APPLICATION NO.	FILING DATE	FIRST NAMED INVENTOR	ATTORNEY DOCKET NO.	CONFIRMATION NO.
10/816,559	03/30/2004	Yew Wee Cheong	111079-136359	1225
25943	7590	12/05/2005	EXAMINER	
SCHWABE, WILLIAMSON & WYATT, P.C. PACWEST CENTER, SUITE 1900 1211 SW FIFTH AVENUE PORTLAND, OR 97204			SHAKERI, HADI	
			ART UNIT	PAPER NUMBER
			3723

Office Action Summary	Application No.	Applicant(s)	
	10/816,559	CHEONG, YEW WEE	
	Examiner	Art Unit	
	Hadi Shakeri	3723

DETAILED ACTION

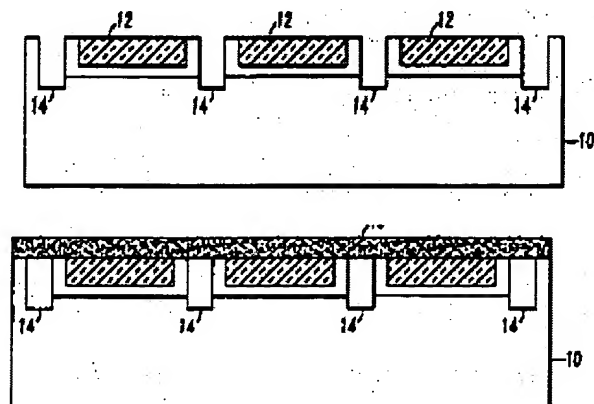
9. Claim 26 is rejected under 35 U.S.C. 112, second paragraph, as being indefinite for failing to particularly point out and distinctly claim the subject matter which applicant regards as the invention.

10. Claim 26 recites for a vacuum transfer device to place the workpiece to tape the first side (front side 205), yet, specification and drawings do not disclose nor describe the device, it is unclear what is being claimed, since there is no description, which indicates that the device is not novel and that the device is already used in the art. It is noted that any attempt to describe by limiting and/or defining the device may be considered as introducing new matter, lacking indication for such support in the specification as originally filed.

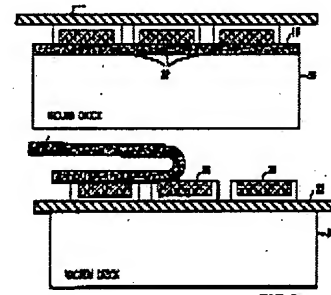
Regarding claims 2, 3, 18 and 19, Riding et al. in view of AAPA as indicated above meets all of the limitations, except for disclosing laser scribing and dicing the wafer, but as indicated by Applicant, e.g., page 6, lines 3-7, it is known in the art for low-K wafer to first laser scribe the wafer and then saw cut it. It would have been obvious to one of ordinary skill in the art, at the time the invention was made, to further modify the above method by laser scribing and saw cutting in view of AAPA to prevent cracking, for wafers having ILD layers.
